<b>To</b>	NDB Subcommittee	<b>Date</b>	February 15, 2017
<b>From</b>	Sam Buckwalter sam.buckwalter@sae-itc.org tel +1 443-454-0584	<b>Reference</b>	17-021/NDT-170 lth
<b>Subject</b>	<b>Working Paper Circulation</b> <b>NDB Subcommittee</b> <b>March 7-9, 2017, Cocoa Beach, Florida</b>		
<b>Attachments</b>	<b>Subject</b>	<b>Source</b>

# **ARINC 424 NDB**

## **Draft 1 of Supplement 22 Discussion**

**Location Cocoa Beach, Florida  
March 7-9, 2017**

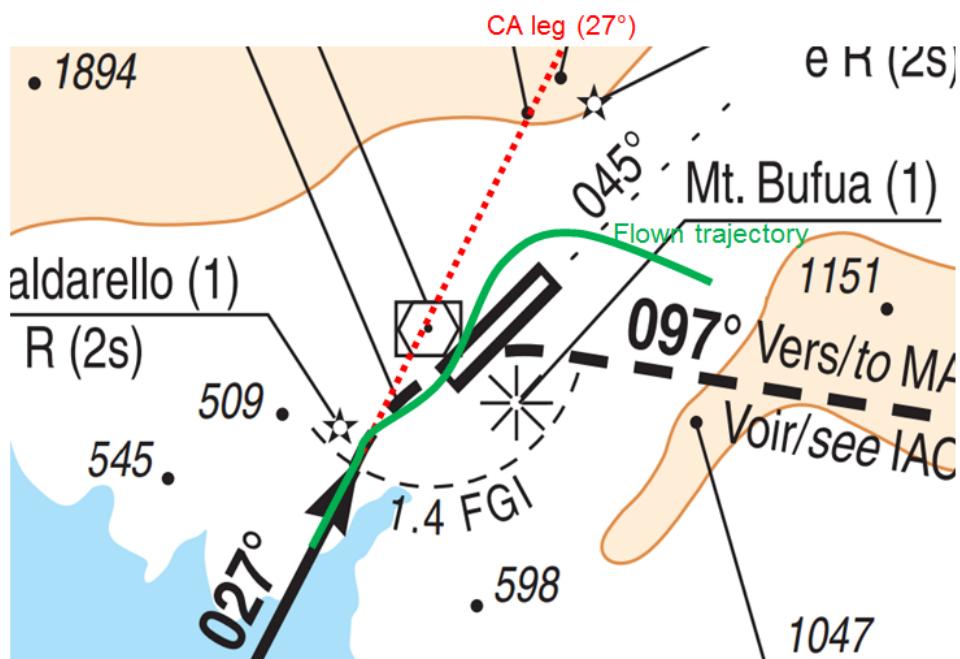
As presented in the figure below this approach calls for a final approach course of 027°, whereas the runway axis is at 045°. Consequently after the MAP a right turn will be performed by the crew, in visual references with AP OFF. In case of missed approach a further 097° right turn shall be performed (missed approach instructions below)

During the aforementioned flight test it was noticed that upon initiating a go-around manoeuvre at low height above the runway (after the final right turn), the aircraft Flight Director commanded an immediate left turn (instead of the missed approach's right turn to 097° expected by the crew).

After study of the approach coding it was noticed that the first leg of the missed approach is coded as a CA with the same course as the final approach segment ( $027^\circ$ ) and ending altitude 490 feet.

- Then the crew will have started to align the A/C with the runway axis (AP OFF)
- The FMS will therefore command an immediate turn to try and guide the A/C back onto the active Missed Approach xA leg (visible with the FD roll bar if AP is not re-engaged)
- In the case of the LFKF approach, we can see that this turn can be in the opposite direction from the Missed Approach briefing (immediate right turn) and be very confusing for the crew.

From the case in LFKF VOR05 it can be concluded that, in such a scenario, the requirement can lead to an opposite effect by generating undue roll commands in the most sensitive part of the final approach (lower height).

2. Also as presented in the LFKF scenario, based on the approach / missed approach geometry, the coding can induce guidance commands to the opposite side of the briefed missed approach. These may seem misleading to the flight crew.

Airbus requests the group’s position on whether these rules satisfy the operational needs and if further detail could be added to req 9.3.1.5 in order to avoid cases such as the one presented.

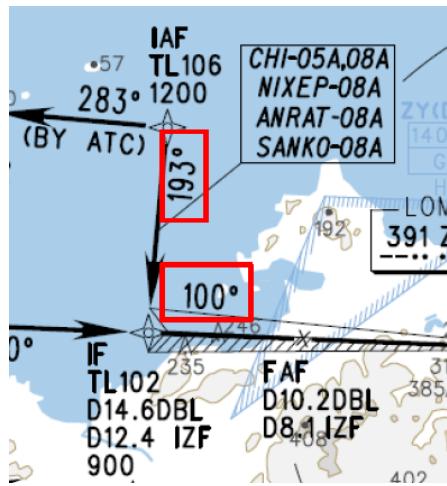
The current wording of section 6.3.6.4 may suggest that any intercept, regardless of path terminator type, cannot intercept the IF/FACF at an angle greater than 90°.

While most procedure source around the world intercepts the IF/FACF at or below 90°, there are some examples where the intercept at the IF/FACF may be over 90°. The below is one such example which can be found in China. With the addition of RNAV transitions into ILS final being more and more common, there may be a growth of procedures that may intercept the IF/FACF at angles slightly over 90°.

Amend the wording of 6.3.6.4 to take into consideration newer ILS procedure designs and to better define the intercept tolerance. The changes proposed will allow an angle greater than the current limit of 90° to be coded if provided by source documentation if the distance from the FACF and FAF is of sufficient distance to allow the aircraft to successfully intercept and track the localizer before reaching the FAF. Proposed distance is 4nm but can be amended based on discussion.

**6.3.6.4** Legs ending in an intercept will ideally be at angles of 30 degrees to the track intercepted. Angles ~~between 10 and 90 degrees~~ greater than 30 degrees may be coded as required by source documentation, provided the resulting intercept is within the reception area of the localizer and the distance between the FACF and FAF is at or greater than 4NM.
